Staff Report

Bourbon County Joint Planning Commission
Public Hearing: March 15, 2018

Case Number: MS 18-02
Applicant: Centrust Capital Homes LLC
Location: North Middletown Rd.
MS Request: Preliminary Major Subdivision (MS)
Zoning: R-2 and R-3 (Residential) in the City of Paris
Parcel Size: 13.43 acres
Application Date: February 19, 2018
TRC Meeting Date: February 26, 2018
Legal Notification: March 1, 2018 - Bourbon County Citizen
Surveyor/Engineer: Thoroughbred Engineering

UTILITY MAP

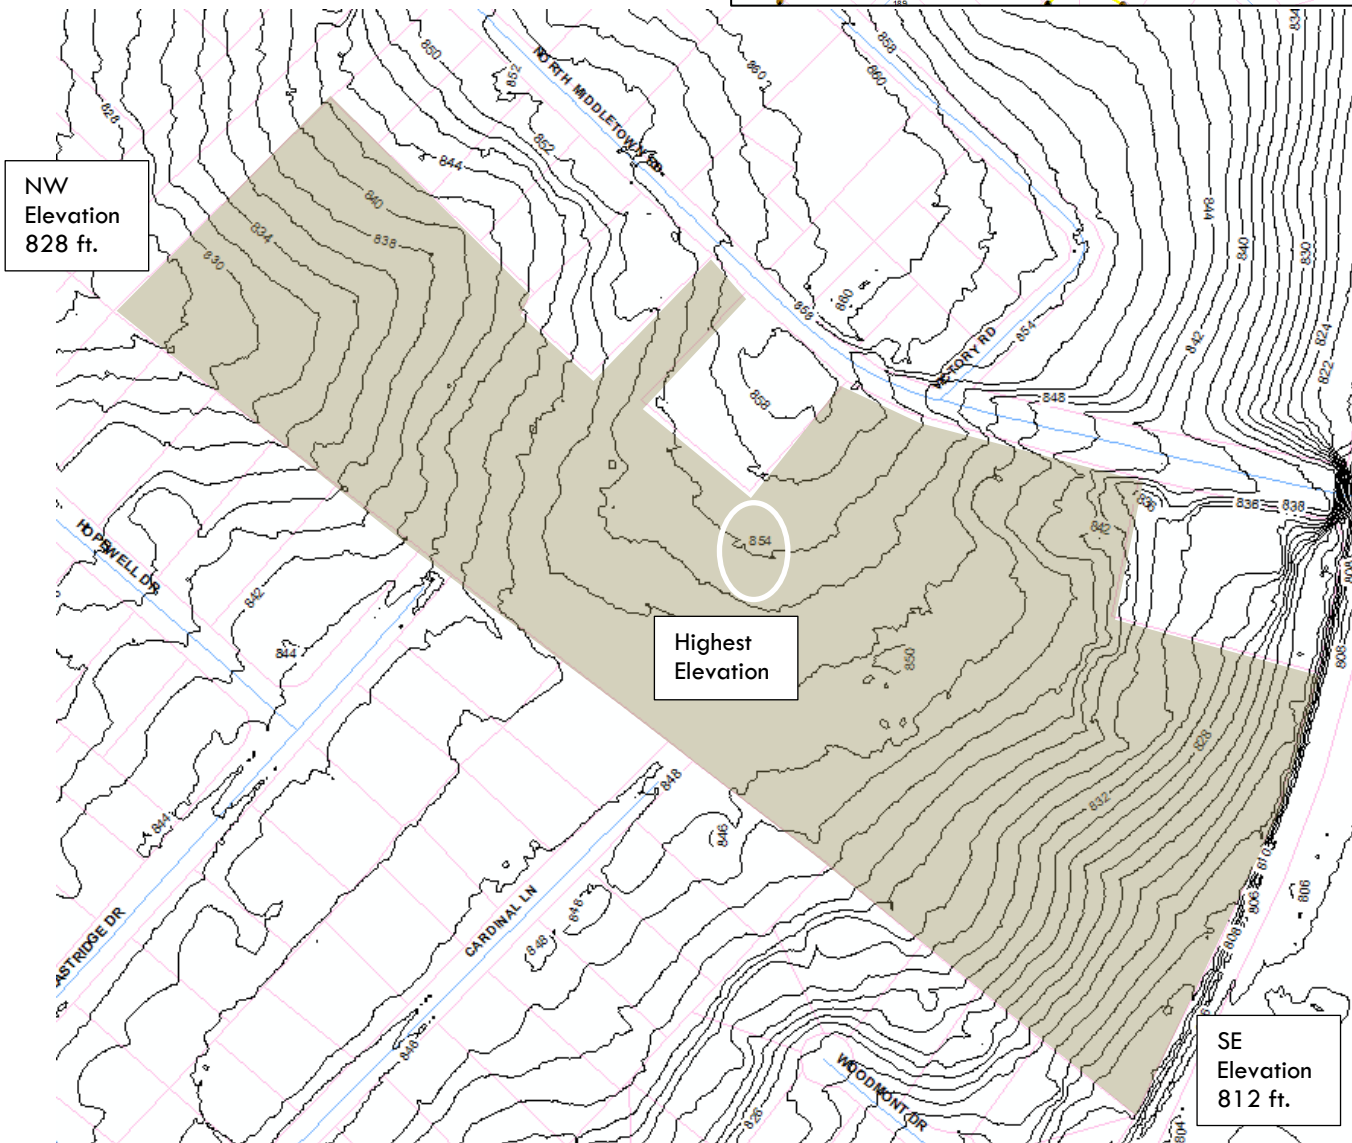
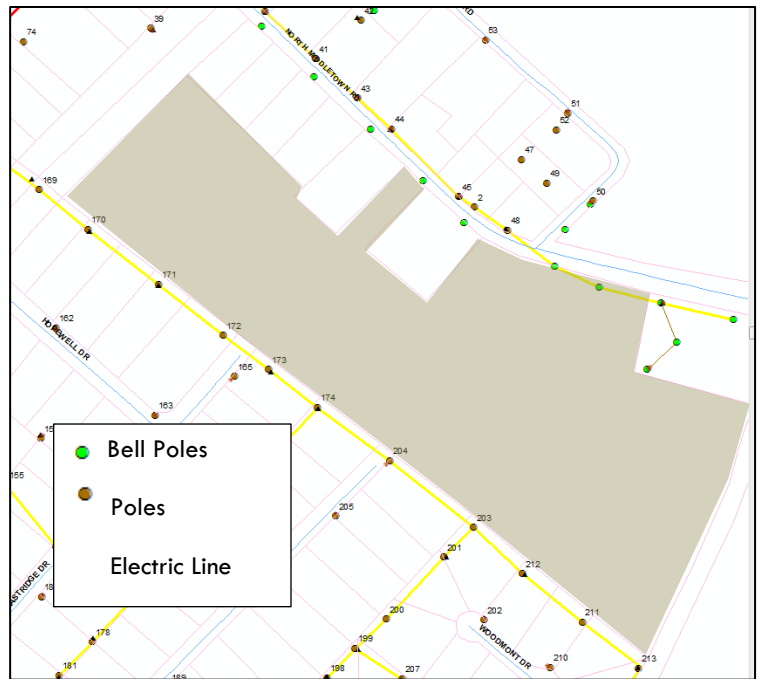
Utilities – All utilities, including electric, gas, water, telephone, and cable are within the vicinity, but will need to be extended to serve the subject property.
